**SUPPLEMENTAL COMMENTS OF INTERNATIONAL PAPER COMPANY (IP) AND
MCGINNES INDUSTRIAL MAINTENANCE CORPORATION (MIMC) ON THE REMEDIAL
ALTERNATIVES FOR THE SAN JACINTO RIVER SUPERFUND SITE (SITE)**

**COMMENTS OF INTERNATIONAL PAPER COMPANY (IP) AND MCGINNES INDUSTRIAL
MAINTENANCE CORPORATION (MIMC) ON THE REMEDIAL ALTERNATIVES
FOR THE SAN JACINTO RIVER SUPERFUND SITE (SITE)**

Figure 1 - Overall Project Cost and Effectiveness¹⁰

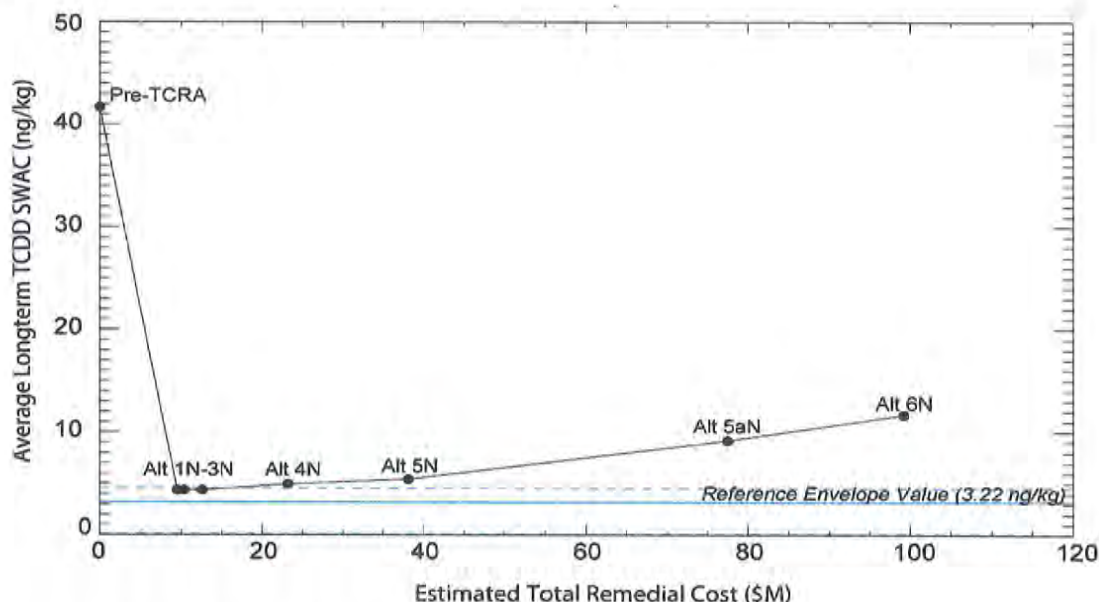
The figure below compares the overall project cost and projected effectiveness for each of the alternatives.

Figure 1 demonstrates that Alternatives 1N, 2N, and 3N provide an equal reduction in the surface-weighted average concentration (SWAC) of dioxins in sediments in the river within the USEPA's Preliminary Site Perimeter. Alternatives 4N, 5N, 5aN, and 6N, on the other hand, result in predicted increases in the SWAC for dioxins in river sediments due to dredging-related impacts. While Alternatives 5N, 5aN, and 6N would remove materials with higher dioxin concentrations, they would reduce—rather than increase—the protectiveness of the remedy because of the impacts from construction. These alternatives are also incrementally and substantially more expensive because of their complexity and duration. Further, even assuming that no resuspension, other impacts, or residuals would occur during implementation of Alternative 4N, 5N, 5aN, or 6N (a situation that has not been observed at any environmental dredging project to date), no incremental protectiveness in the SWAC would occur as a result of the implementation of any of these alternatives, yet there would be a substantial and disproportionate increase in cost. Hence, these alternatives would not be considered cost-effective under CERCLA and the NCP because they would not provide additional protectiveness in comparison to the disproportionate incremental cost.
